PRODUCT CHANGE NOTIFICATION

#PCN-DC-W0XA-13

Business Unit	Product Line Code	Type of Change	Action	Date of issue
DC	ABO	Mechanical	Notify Distributors and Field	8/21/2013

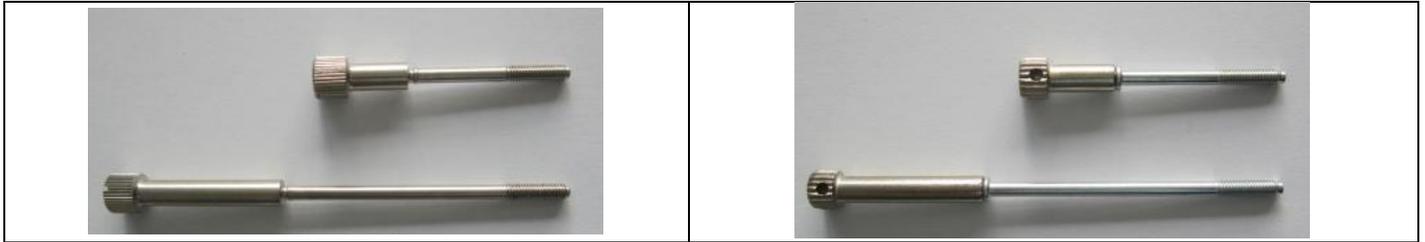
The manufacturing procedure for mounting screws with knurled head is subject to a change. The threaded shaft is made of steel, the shaft with the knurled head of is composed of a CuZn alloy. To ensure that both sides of the mounting screws can be sealed, both screws receive a sealing hole through the knurled head.
